# INDEPENDENT STRUCTURAL ANALYSIS FOR THE CORPUS CHRISTI NEW HARBOR BRIDGE PROJECT

## TECHNICAL MEMORANDUM

### DELTA FRAME – TO – BOX GIRDER CONNECTION

DOCUMENT NUMBER: TM1003

Figure 2: Delta Frame Tendon DT2 & DT3 Anchor Block Details (NB Shown, SB Similar) – Schematics by Others

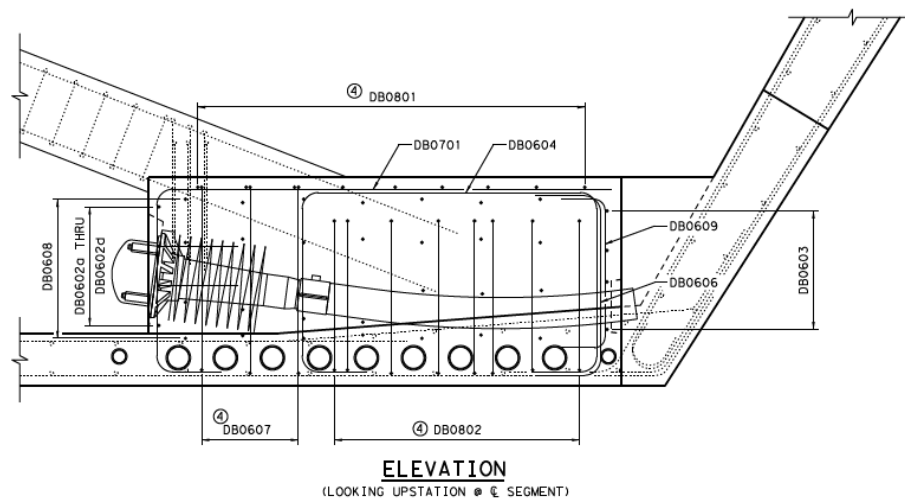
AASHTO LRFD §5.8.4.1 requires, “The minimum area of interface shear reinforcement specified in Article 5.8.4.4 shall be satisfied.” In the current design as shown in Figure 2 below, there has been no interface reinforcement provided across the interfaces between the cast-in-place pour-back and the bottom precast segment DF2 & DF3 anchor block nor between the pour-back and the precast delta frame. This does not meet the requirements of AASHTO LRFD §5.8.4.1 and §5.8.4.4.

These unreinforced interfaces, which must be able to transfer axial load, shear, and flexure from the box girders to the delta frames, lack a ductile means to adequately resist flexure and shear at this critical connection. The DF2 and DF3 post-tensioning tendons cross two of these interfaces. However, AASHTO LRFD §5.8.4.1 does not include post-tensioning as an acceptable means to resist interface shear. Further, literature cited in the AASHTO LRFD Commentary and other relevant literature lack experimental research to support the sole use of post-tensioning to provide ductile interface shear resistance without interface reinforcement allowed by AASHTO LRFD §5.8.4.1: single bars, multiple leg stirrups, or welded wire fabric.

Flexural moments under Service (and Strength) limit state loadings cause top fiber tensile stresses across the interface that exceed the no tension allowable limits of AASHTO LRFD §5.9.4.2.2. There is no reinforcement to arrest cracking in the pour-back, and so the current design also does not meet the requirements of AASHTO LRFD §5.7.3.4. As cracks deepen, the ability of the interfaces to resist shear decreases. The shear from each box girder (NB and SB) must transfer through these interfaces to the delta frame on its way to the support at the stays. Well anchored reinforcement must be provided

across both interfaces of the pour-back to satisfy the above-referenced requirements. Without this reinforcement, brittle failure of these critical connections cannot be ruled out.

Figure 2: Delta Frame Tendon DT2 & DT3 Anchor Block Details (SB Shown, NB Similar) – Schematics by Others

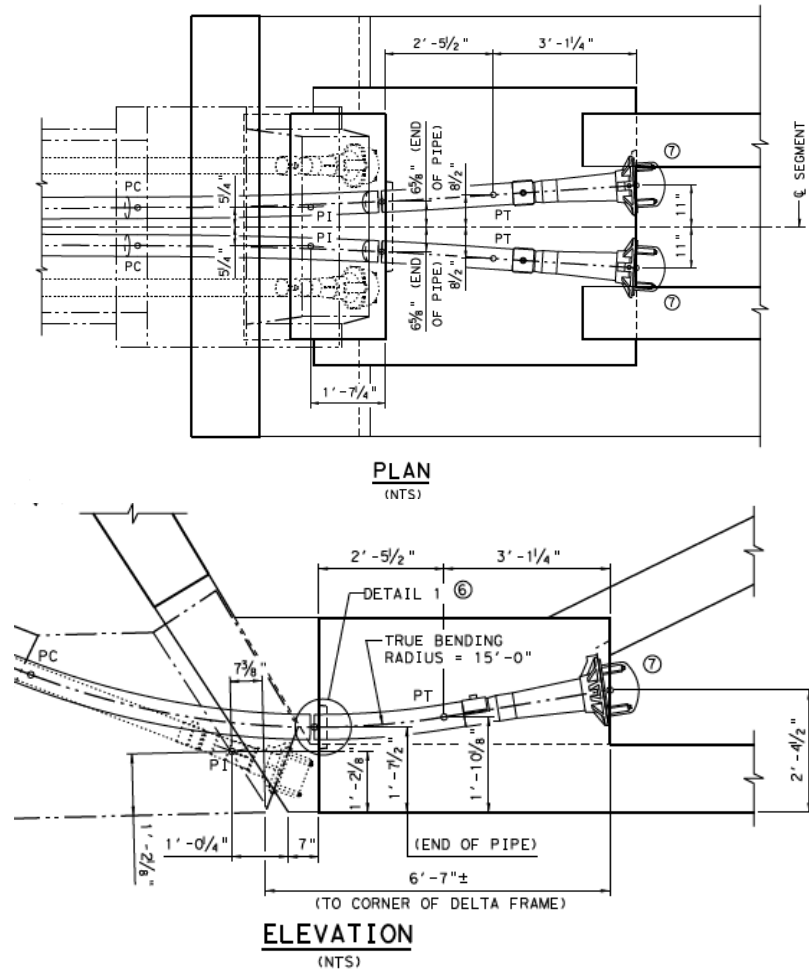
The unreinforced pour-back also does not meet some of the requirements of AASHTO LRFD §5.10 – Details of Reinforcement (e.g., minimum reinforcement spacing requirements, temperature and shrinkage requirements, effects of curved tendons, etc.). Referring to Figure 2 below, the pour-backs must resist radial stresses from the 2 x 31-strand tendons that deviate through this element with a 15' radius. Without reinforcement, the pour-back does not have a means to meet the requirements of AASHTO LRFD §5.10.4.3.

The characteristics of the cast-in-place pour-back material has not yet been specified in the Current Design; therefore, the it does not meet the requirements of AASHTO LRFD §5.4.1. Also, the above-referenced FDLLC Letter shows that the delta frame surface adjacent to the cast-in-place pour-back has not been intentionally roughened to a minimum amplitude of 1/4" to maximize cohesion and friction properties of the interface, as was specified for the bottom precast segment DF2 & DF3 anchor block vertical face adjacent to the cast-in-place pour-back.
